Technical Bulletin 193

11.2018

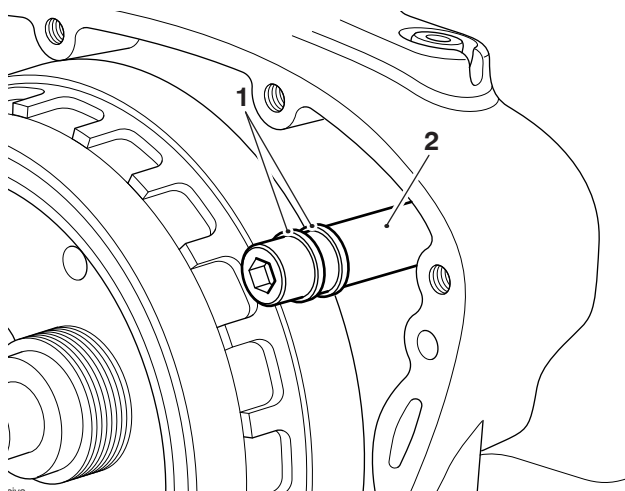
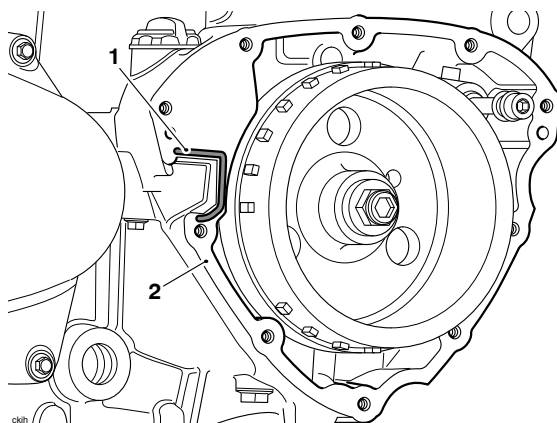
When installing the alternator cover to the crankcase on the above models ThreeBond1216E sealant is used in addition to the gasket in the area of the alternator harness grommet.

- When using ThreeBond1216E the mating faces must come into contact with each other within five minutes of application.
4. Apply a 2 mm (+/-0.5 mm) bead of silicone sealant to the outer surface of the gasket in the area shown in the diagram below, during manufacture, ThreeBond1216E is used.

1. Sealant area

2. Gasket

ckjc

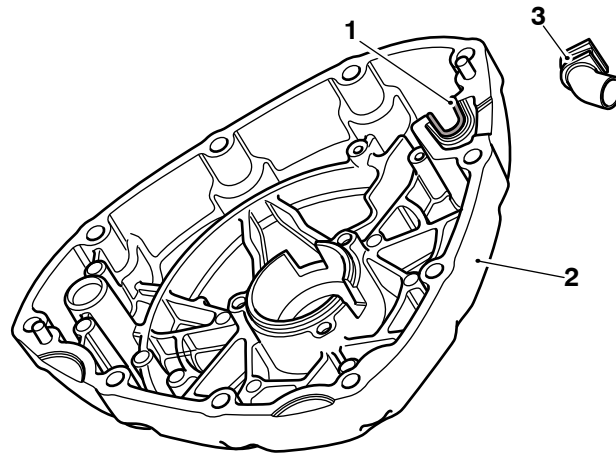
5. Apply a 2 mm (+/-0.5 mm) bead of silicone sealant to the area of the alternator cover at the location of the harness rubber grommet as shown in the diagram below, during manufacture, ThreeBond1216E is used.

- 1. Sealant area
- 2. Alternator cover
- 3. Rubber grommet (harness removed for clarity)

Tightening Sequence

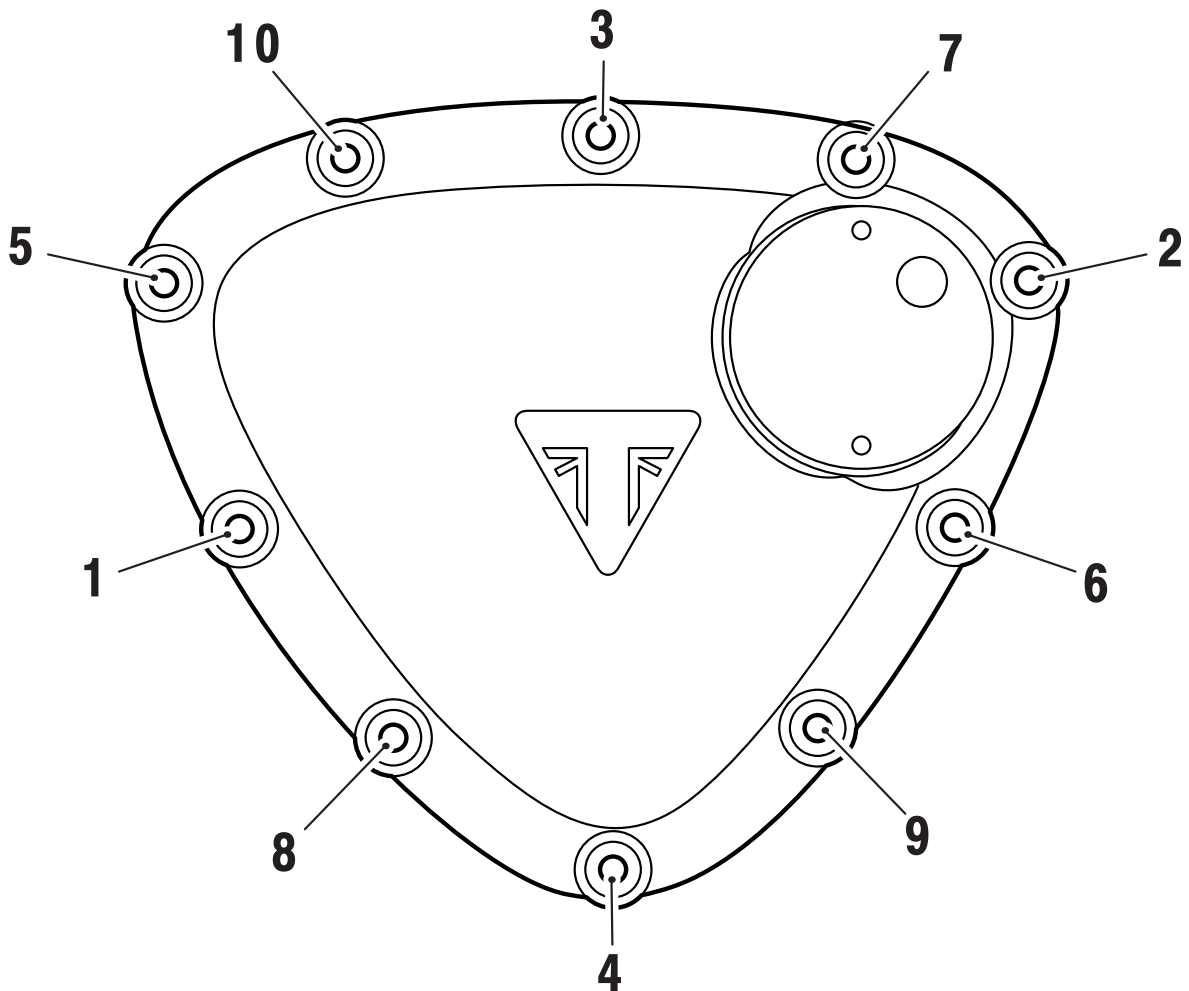
6. Fit the alternator cover and tighten the fixings to **10 Nm**, in the sequence shown below.

-
7. Re-tighten fixings one and two to **10 Nm**.
 8. Refit the alternator harness as noted in the Service Manual.
- When ordering replacement parts, refer to the EPC.

Circuit Diagram

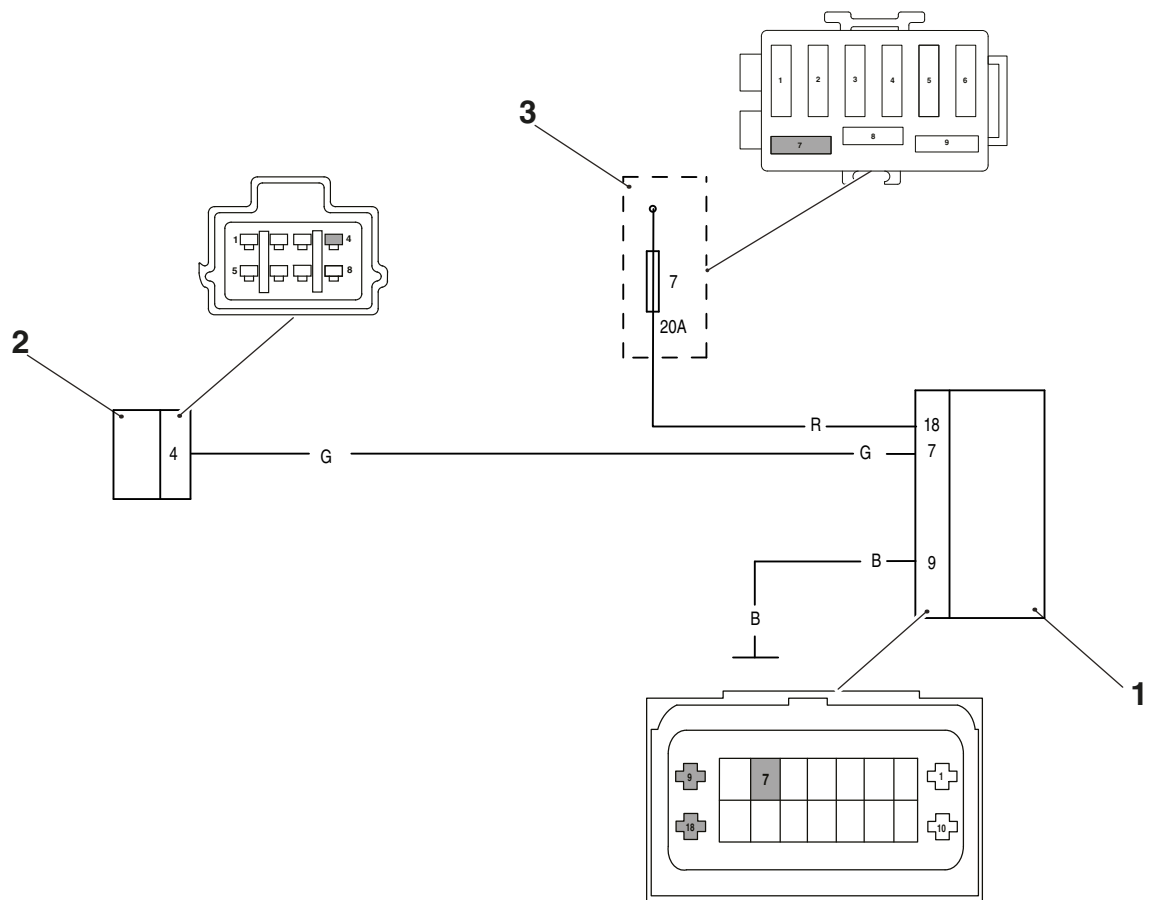
The pinpoint test for Power Source Voltage Drop/Voltage Rise (C1661 and C1662) has changed for the above models. This information amends the current Service Manual section of TriTun - Brakes - Pinpoint Test - Power Source Voltage Drop/Voltage Rise.

The revised pinpoint test is as described below.

Test	Result	Action	
1	Check battery Voltage: - Battery positive (red) terminal and negative (black) terminal Check fuse 7 integrity Check cable and terminal integrity: - ABS modulator connector pin 7, pin 18 and ground pin 9	OK	Proceed to test 2
	Faulty	Rectify fault, proceed to test 5	
2	Check the cable for continuity: - ABS modulator connector pin 9 and ground - ABS modulator connector pin 18 and fuse 7 - ABS modulator connector pin 7 and Ignition switch pin 4	OK	Proceed to test 3
	Faulty	Rectify wiring harness fault, proceed to test 5	
3	Check battery Voltage: With ignition ON, check the Voltage between: - ABS modulator connector pin 7 and ground pin 9 - ABS modulator connector pin 18 and ground pin 9	Voltage greater than 10 V	Proceed to test 4
	Voltage less than 10 V	Locate and rectify fault, proceed to test 5	
4	Check battery Voltage: Reconnect ABS modulator connector and start the engine. Check the Voltage between: - Battery positive (red) terminal and negative (black) terminal	Voltage between 10 V and 16 V	Proceed to test 5

Voltage greater than 16 V	Check the battery charging circuit. Locate and rectify fault, proceed to test 5	
5	Clear fault code and test ABS to verify fault cleared	OK	Action complete - quit test
	Fault still present	Contact Triumph service

L0445

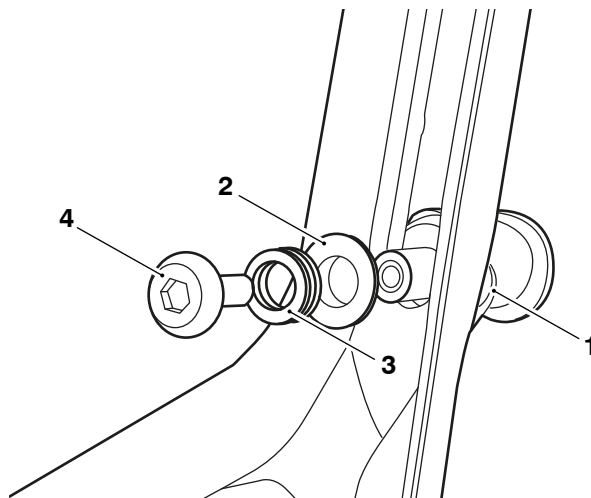
The method for installation of the windscreen has changed.

The windscreen fixing is M5 x 16 mm with a 4.1 mm shoulder

The adjuster fixing is M5 x 17 mm with a 2.1 mm shoulder

The adjuster fixing must be fitted to the adjuster side of the flanged bush and the windscreen fixing to the windscreen side of the flanged bush.

1. **Windscreen fixing M5 x 16 mm (4.1 mm shoulder)**
 2. **Rubber washer**
 3. **Flanged bush**
 4. **Flanged sleeve**
 5. **Spring**
 6. **Adjuster fixing M5 x 17 mm (2.1 mm shoulder)**
3. Position the flanged bush to the outside edge of the windscreen support as shown in the following illustration.
 4. Fit the flanged sleeve and spring to the flanged bush on the inside edge of the windscreen support.
 5. Fit the adjuster fixing, counter hold the flanged bush and tighten the fixing to **3 Nm**.

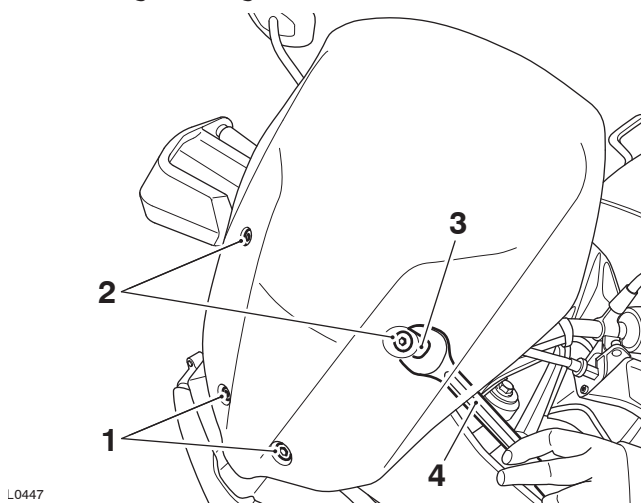
14. Fit the rubber washers to the windscreen side of the flanged bush.
15. Position the windscreen on to its four mounting points.

16. Fit the windscreen upper fixings to the upper mountings, counter hold the flanged bush and tighten the fixings to **3 Nm**.
17. Fit the two windscreen lower fixings and tighten to **3 Nm**.

1. Lower fixings
2. Upper fixings
3. Flanged bush
4. Spanner
